**MODIFICATION OF AUTHORIZATION TO DISCHARGE UNDER THE
NATIONAL POLLUTANT DISCHARGE ELIMINATION SYSTEM**

**Mirant Kendall Station
265 First Street
Cambridge, MA 02142**

Response to Comments
Mirant Kendall Station
NPDES Permit No. MA0004898 – Modification

Figure 4.28-1. Total length frequency distribution (mm) for larval river herring collected in the intake and discharge at Mirant Kendall Station, 2000 (From AR 761).

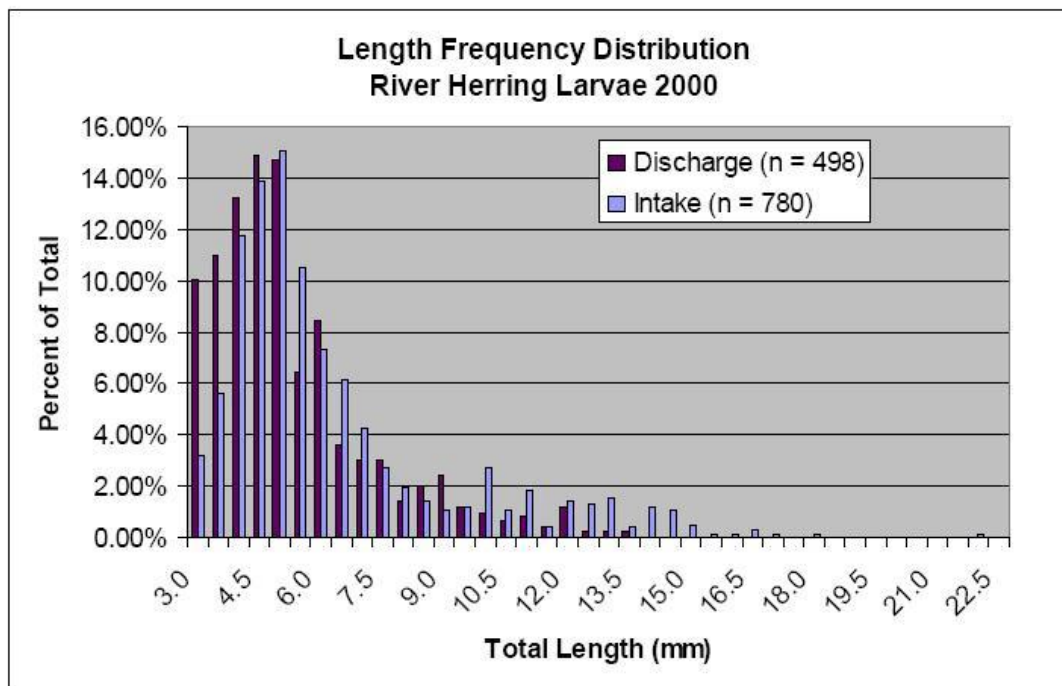
Response to Comment 4.28.1

0.5 fps retained 0 to 1 percent of prolarvae and early postlarvae and 6 to 15 percent of later postlarvae (Table 4.28-1). Based on the ESEERCO study (AR 750) and the average size of entrained larvae at Kendall Station (see Figure 4.28-1), 0.5 mm is the maximum opening size that would effectively reduce entrainment.

1. The SOB intentionally described the smallest aquatic organisms vulnerable to entrainment, which are early stage (yolk sac) larvae and eggs. The relevance of this point in the comment is unclear. Yolk sac larvae are not excluded from assessments of entrainment mortality under CWA § 316(b).
2. A frequency distribution of *Alosa* larvae captured in the intake or discharge indicates that larvae in the Broad Canal predominantly range between 3 and 8 mm (Figure 4.28-1). According to Jones et al. (Appendix III in Exhibit 5, AR 736), the average river herring egg is 1.0 mm. Based on these estimates 0.5 mm would be a conservative opening size for excluding the most commonly entrained species in the Broad Canal. It is important to note that EPA is concerned with protecting the maximum number of eggs and larvae at

Broad Canal, not just the most frequently collected sizes. As such, a more conservative range of larval sizes will provide the greatest degree of protection of all larvae.
